State of Louisiana

Department of Health
Office of Public Health

Re: Class I Sanitary Survey
Village of Estherwood Water System
PWS ID #: LA 1001003
Acadia Parish

Attachment #1

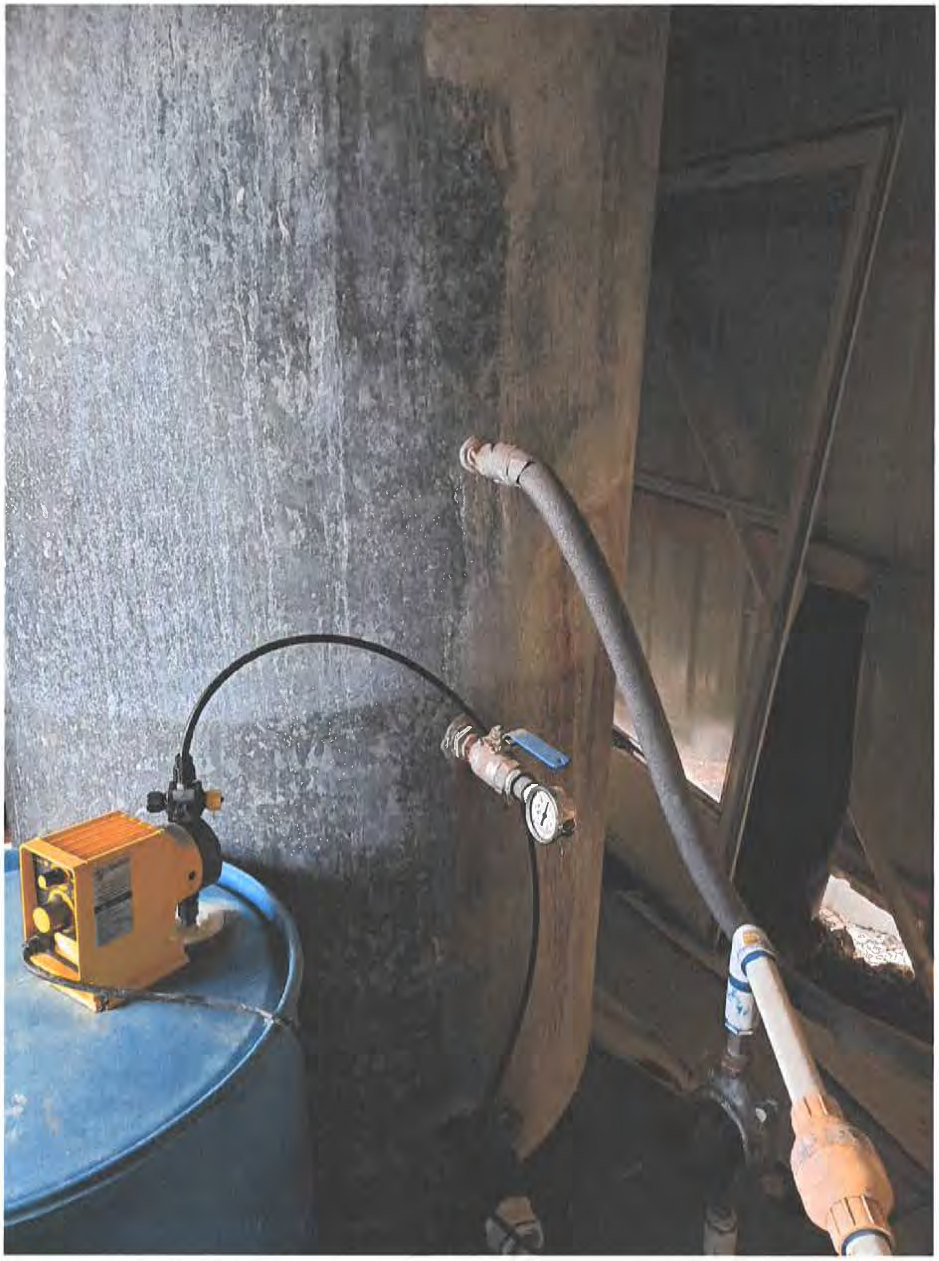
Attachment Comments: A ventilating fan near the floor, air inlets near the ceiling, and a signal light with indicating ventilating fan operation is needed.

Attachment #4

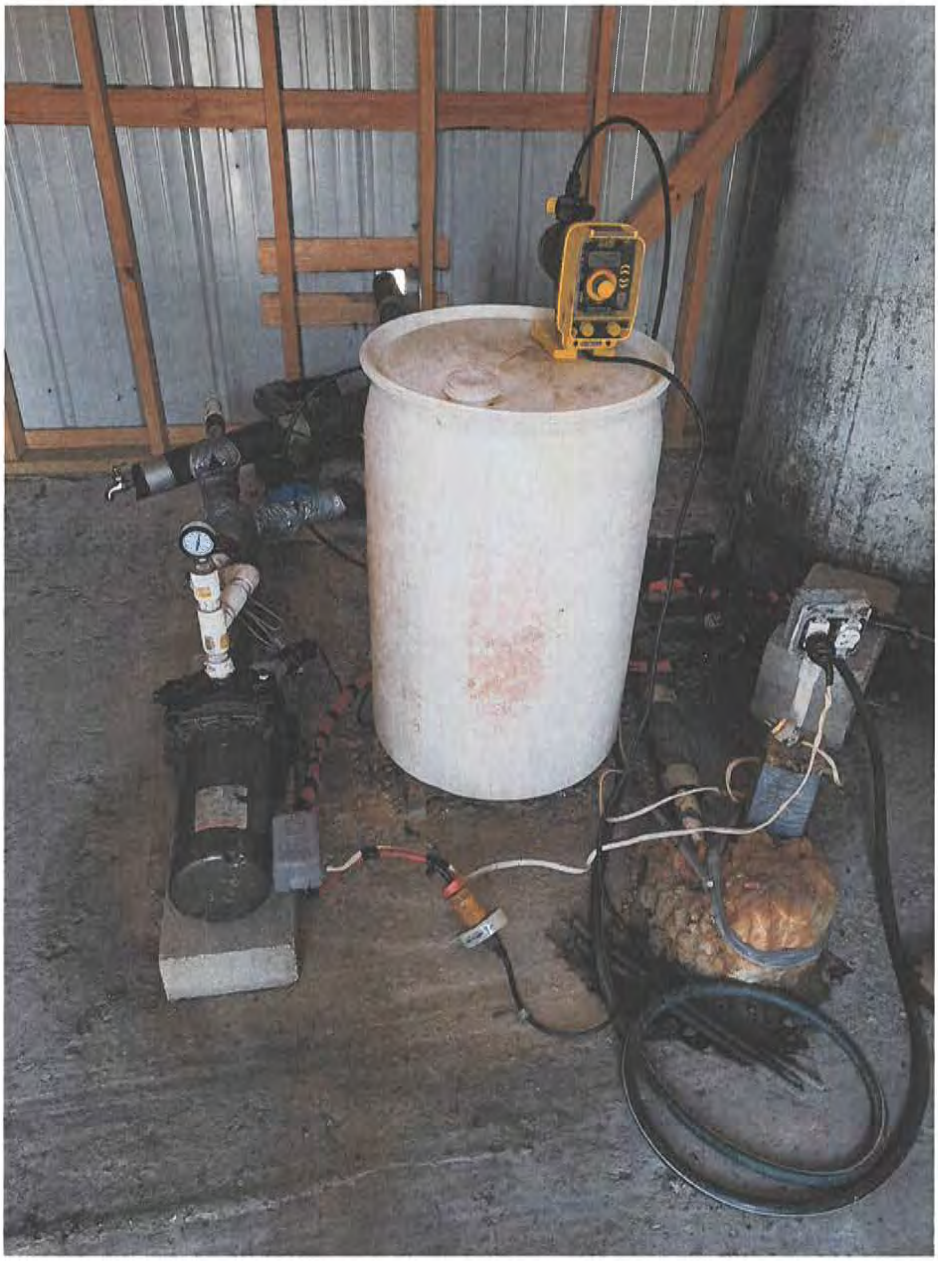
Attachment Comments: All chemicals should be fully labeled and meet ANSI/NSF 60 labeling requirements. Calibration tube for the sodium hypochlorite chemical feed pump is needed.

Attachment #1

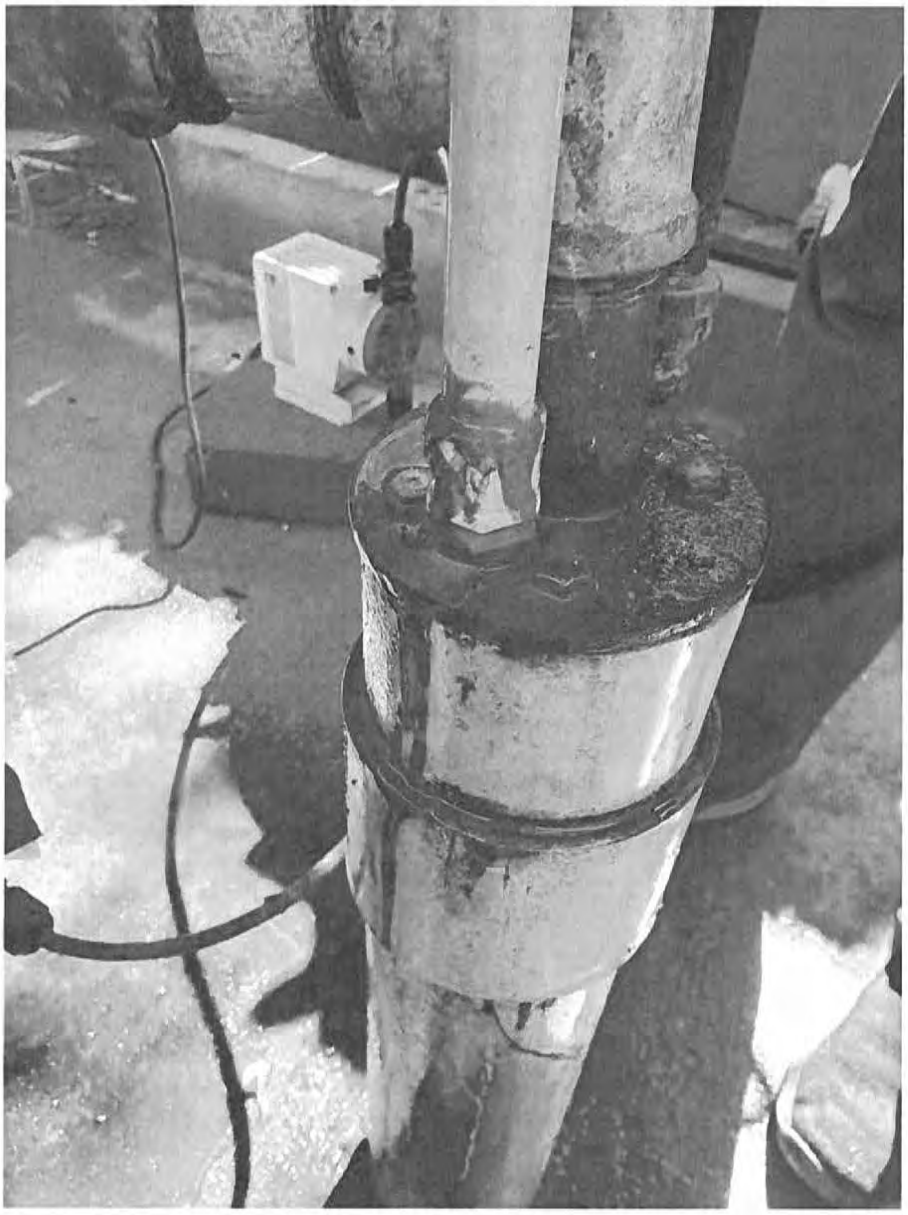
Attachment Comments: At the time of the survey well piping was leaking and when well started water around the leaked area was sucked into the well.

Attachment #2

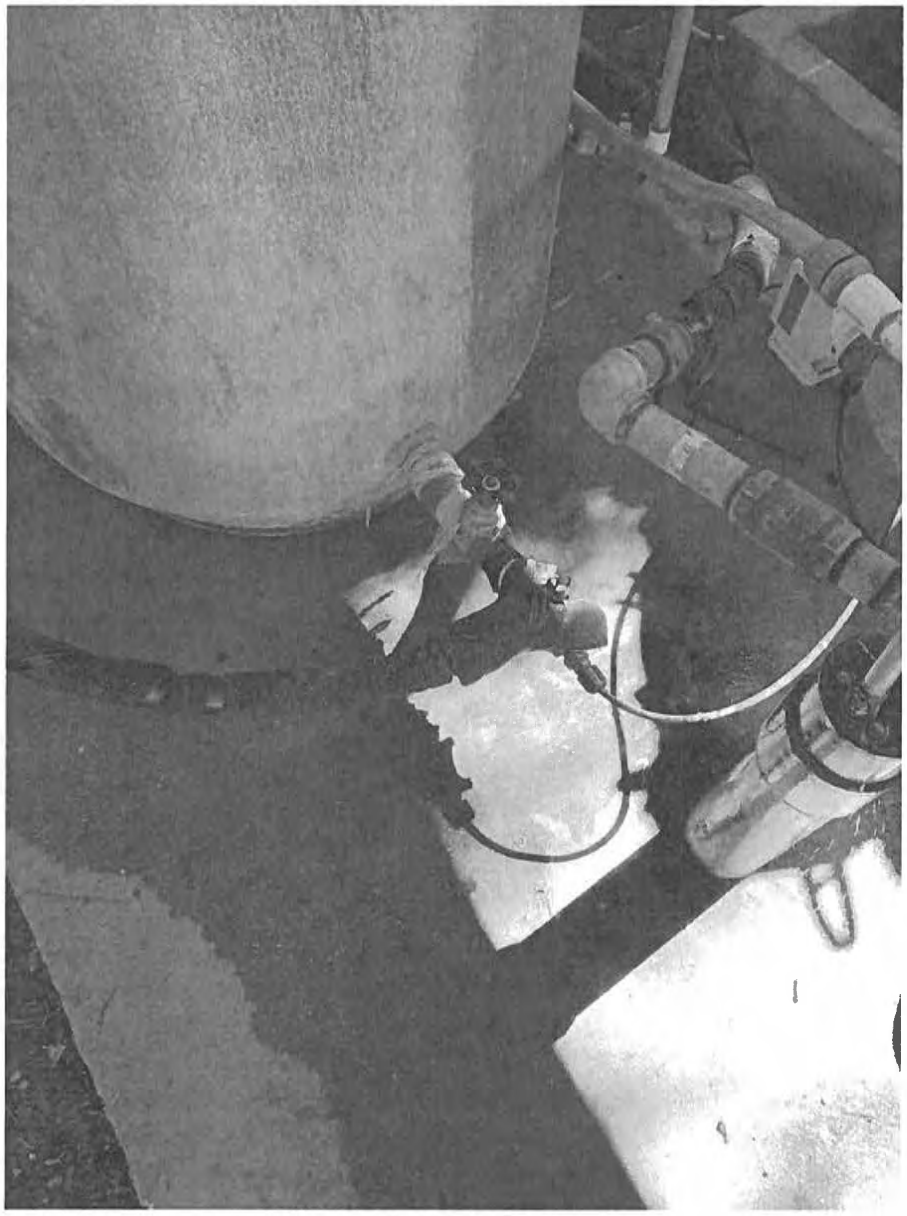
Attachment Comments: The sight glass is in need of repair.

Attachment #2

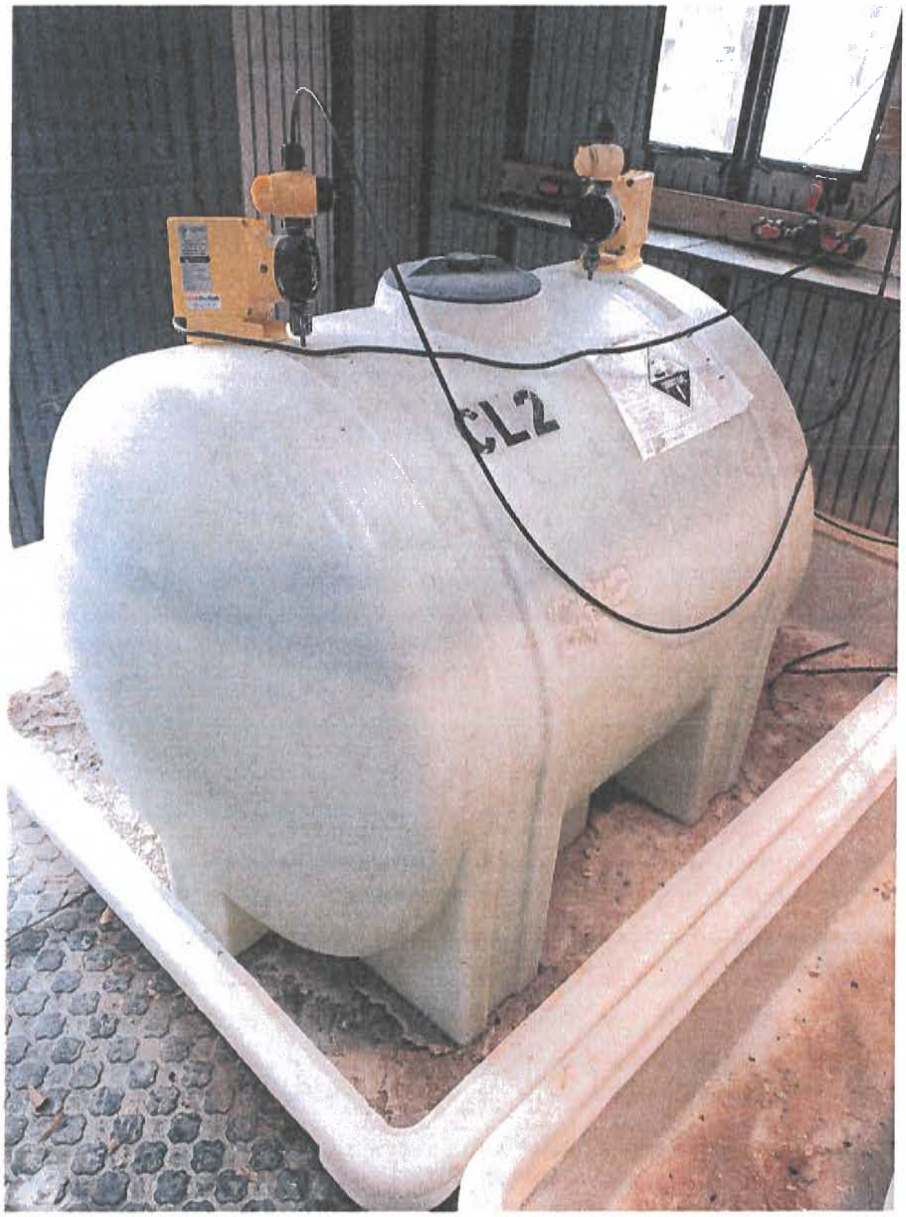
Attachment Comments: The chemical container needs the correct label on it. It should have TMB 461 on it.

Attachment #1

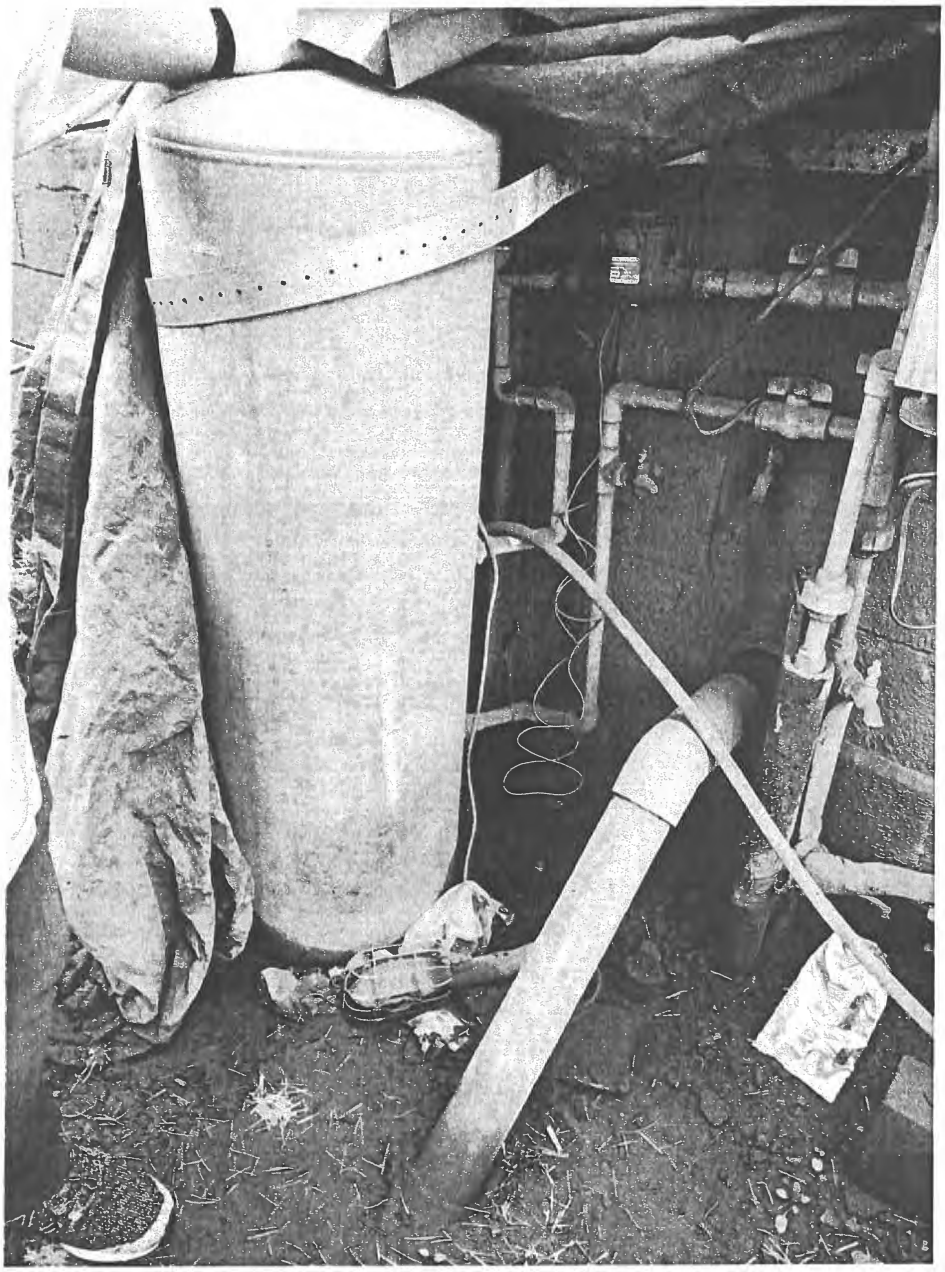
Attachment Comments: This pressure tank should be elevated at least 2 feet off of the ground and not allow entrance of insects, dust or other contaminating material.

Attachment #2

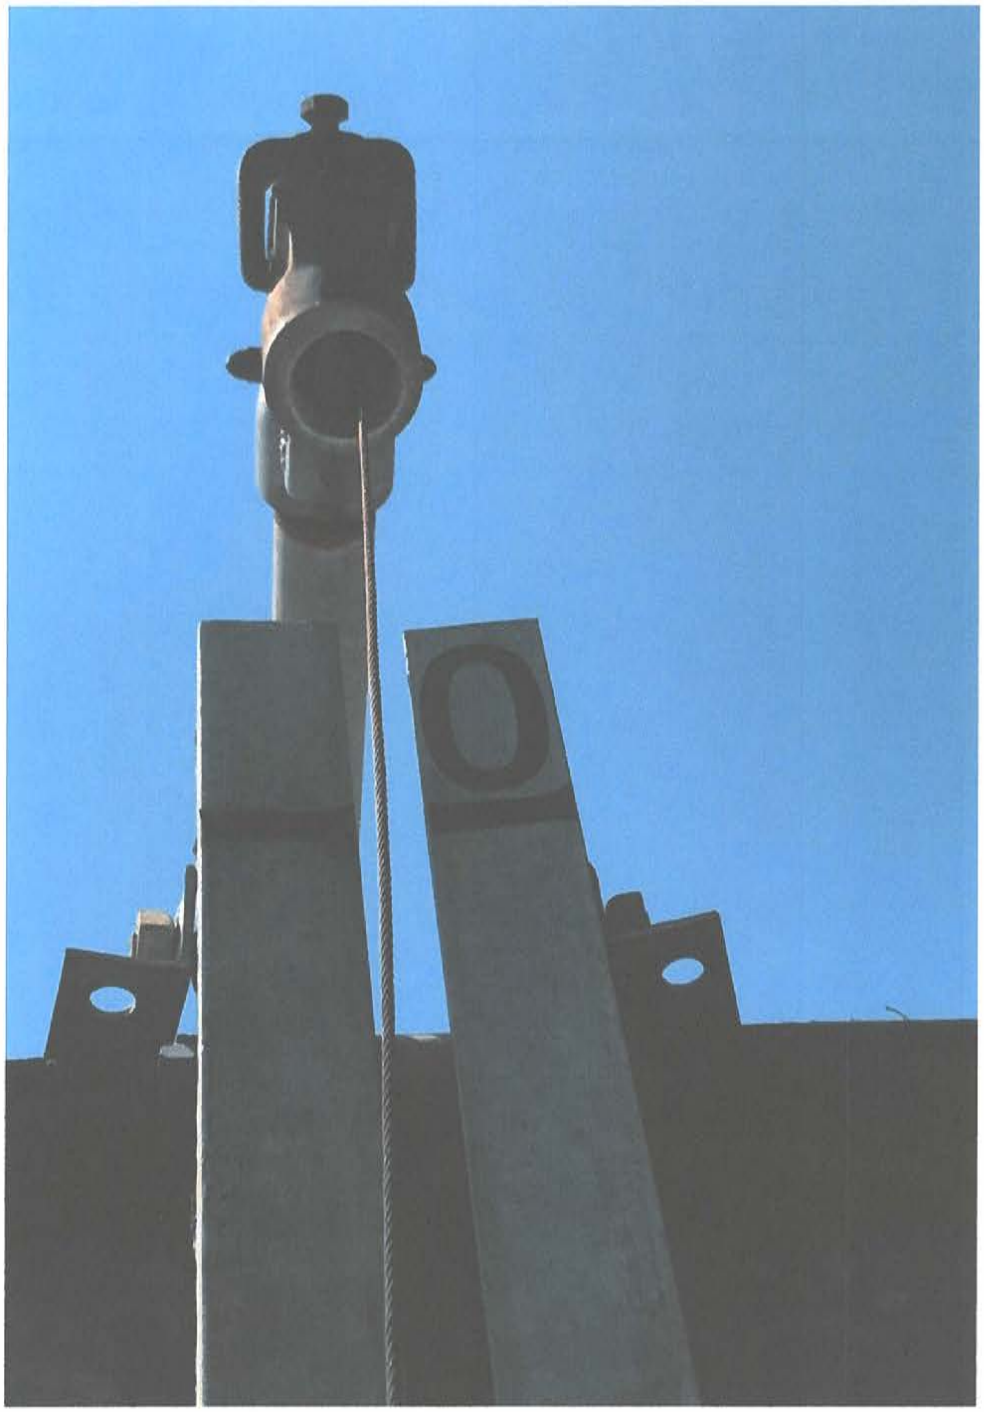
Attachment Comments: Level Gauge open to atmosphere and should be screened

Attachment #2

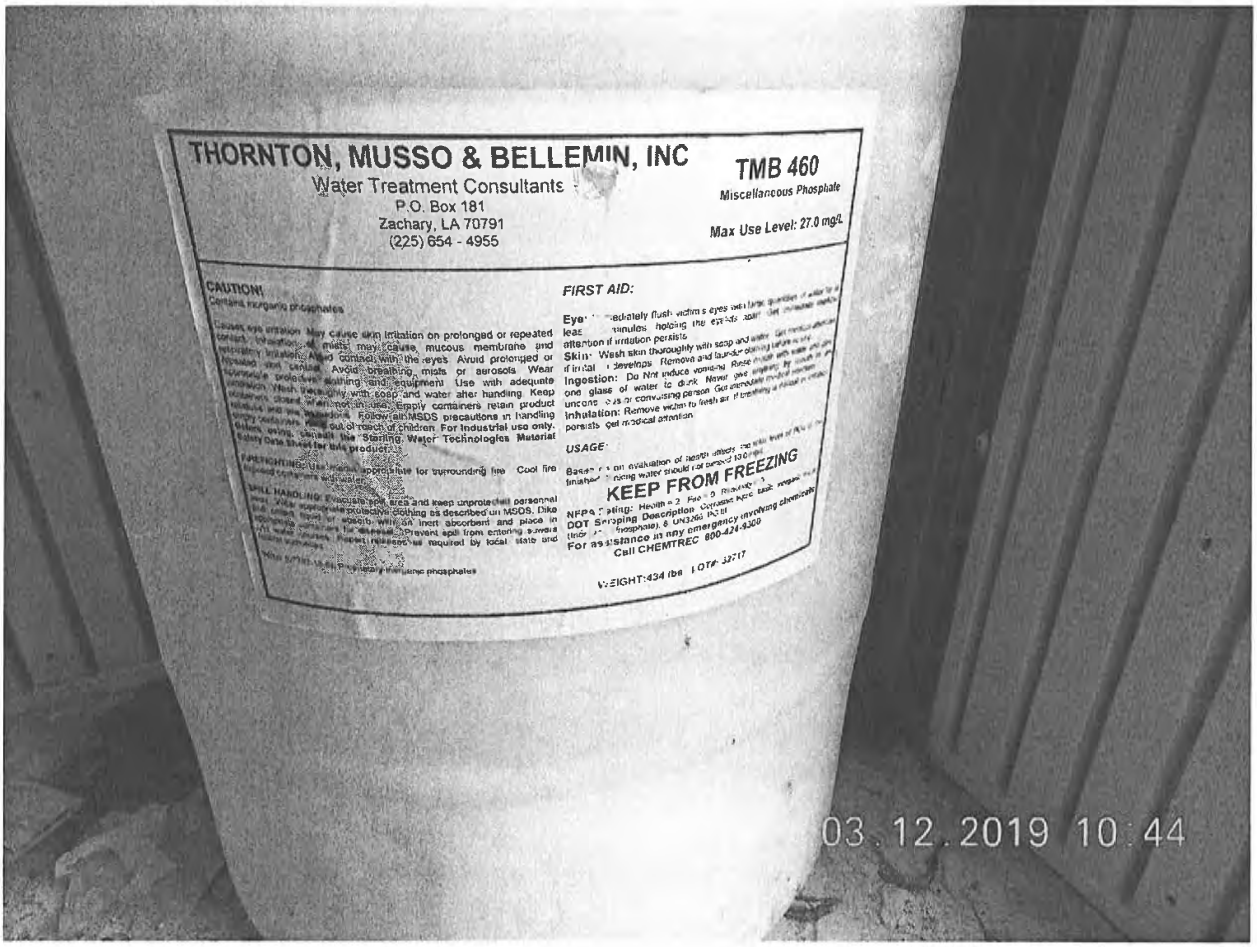
Attachment Comments: The use of polyphosphate for iron and manganese sequestration is a treatment process. There is no testing for phosphates.

Attachment #3

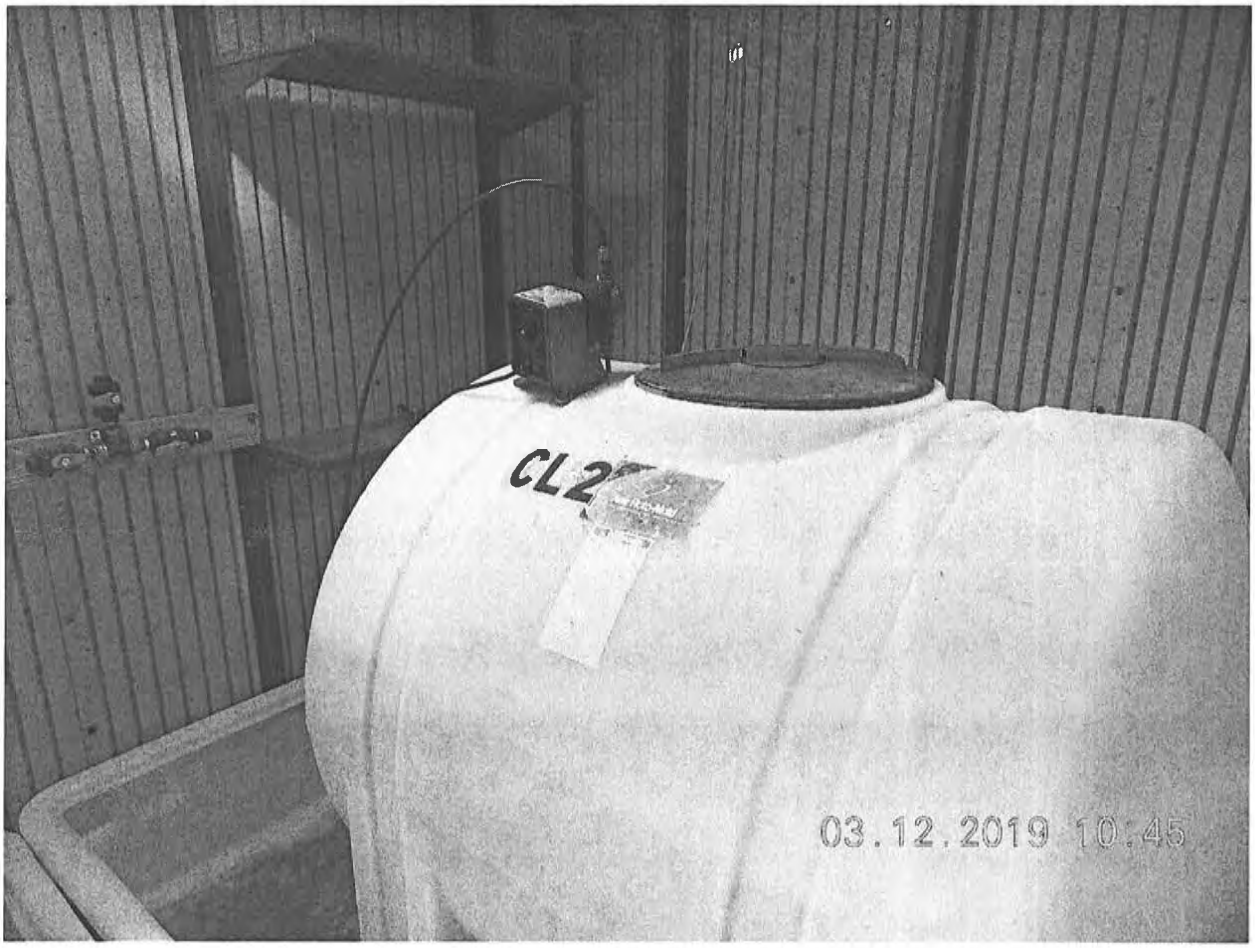
Attachment Comments: The Sodium Hypochlorite Tank does not have a calibration column for the chemical feed pump and the tank is not equipped with a scale on the side of the tank for measuring the daily chemical usage.
